Refining the Definition of $TDECQ_{CER}$

Ahmad El-Chayeb – Keysight Technologies
David Leyba – Keysight Technologies

Addressing comments #112, #113, #114, #115, #117 and #118 against IEEE P802.3dj D2.2

Test Repeatability

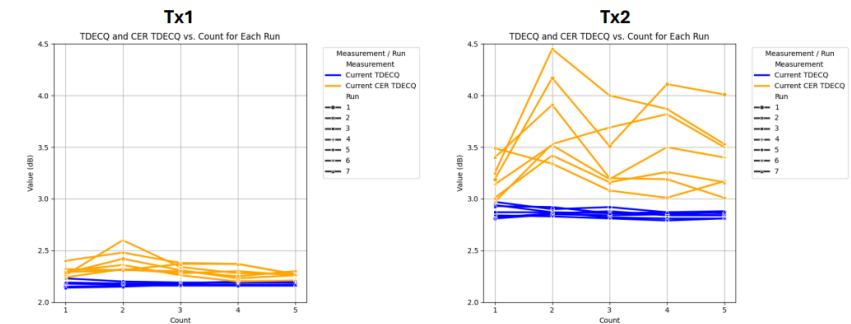
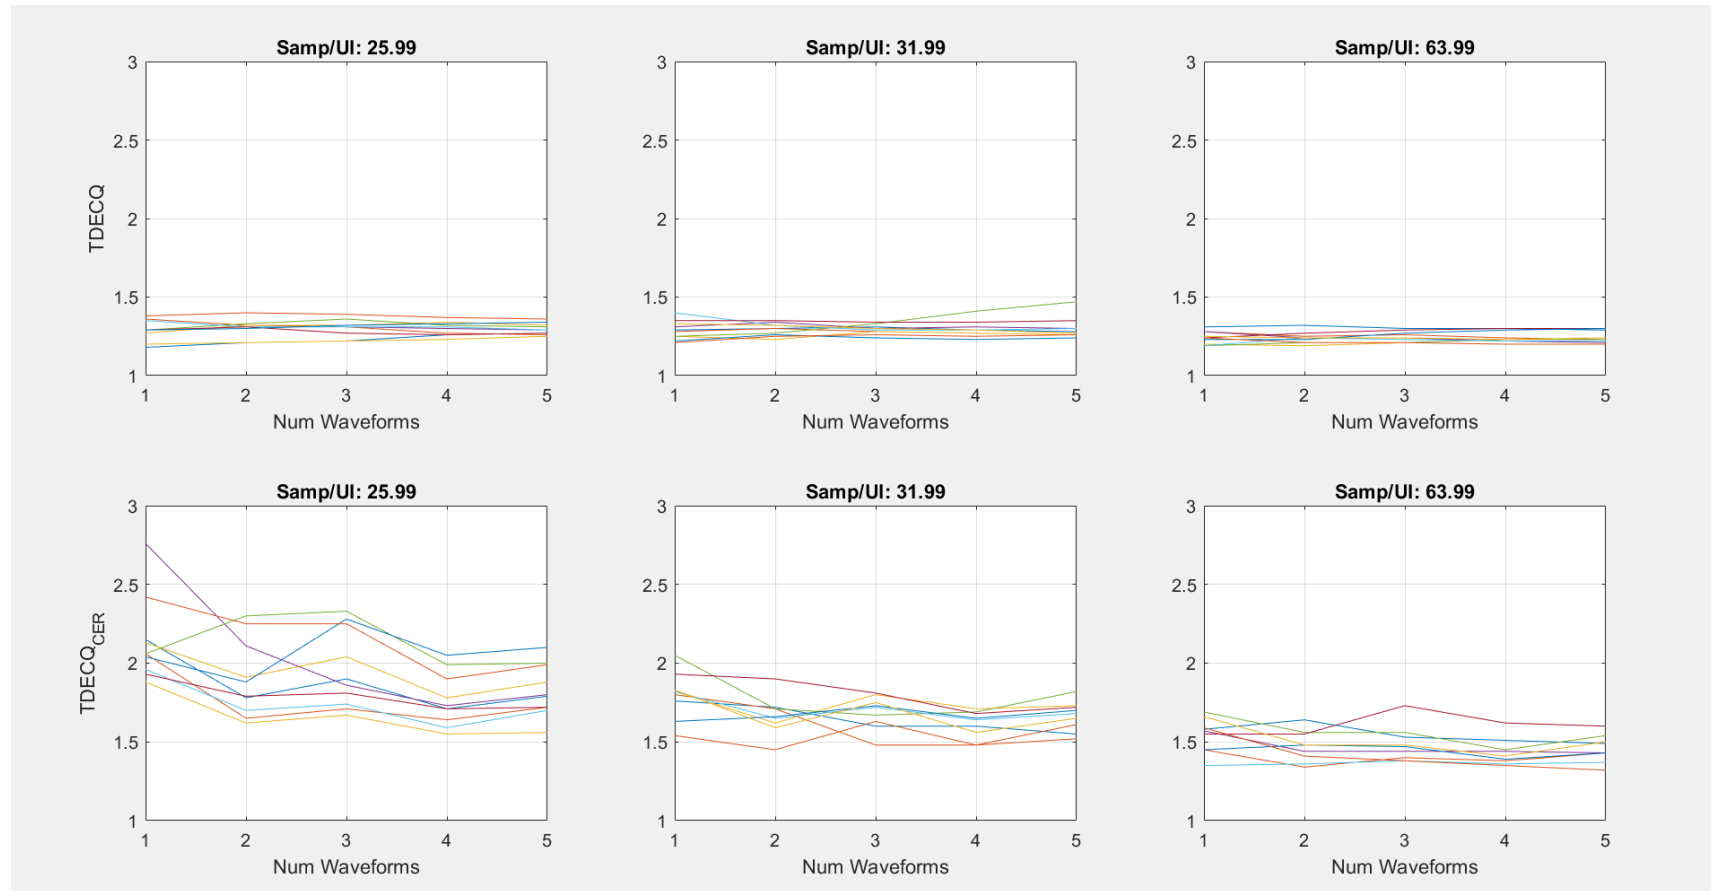
- Record TDECQ and CER TDECQ for every pattern accumulation up to 5 (Count)
- repeating the test 7 times (runs)
- On a higher TECQ Tx and a lower TECQ Tx

CER TECQ can vary and does not seem to converge when collecting more data (up to 5 counts)
The variation is higher for high TECQ Tx
